Equipment Technical Bulletin

Summit OPL and XL Flush Manifold Reliability Upgrade

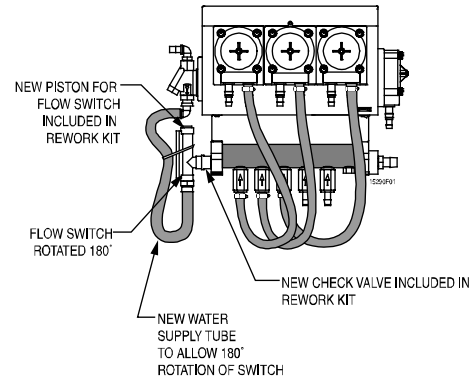
Laundry dispensers equipped with flush manifolds stop operating or operate in an unsafe manner due to piston sticking in the safety flow switch.

If the piston sticks in the “flow present” position, the dispenser could fill the flush manifold with chemicals without flushing them out. This may result in the release of chlorine gas if chlorine bleach and sour are mixed or an explosive condition if alkali and peroxide are mixed.

The piston has a tight tolerance in the switch body that makes it highly susceptible to sediment buildup. The check valve between the flow switch and flush manifold does not reliably stop the migration of chemical product back into the flow switch. This can exacerbate sediment accumulation on the piston, ultimately causing it to stick.

Summit OPL with Flush Manifold and Parts Included in Upgrade Kit

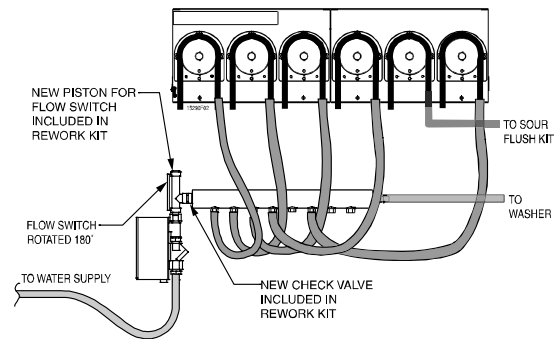
- An upgrade kit consisting of an improved check valve and looser-tolerance flow switch.

Our lab tests showed an improved resistance to debris in the water supply if the flow switch is rotated 180 degrees. The Installation Instructions with the upgrade kit explain how to do this.
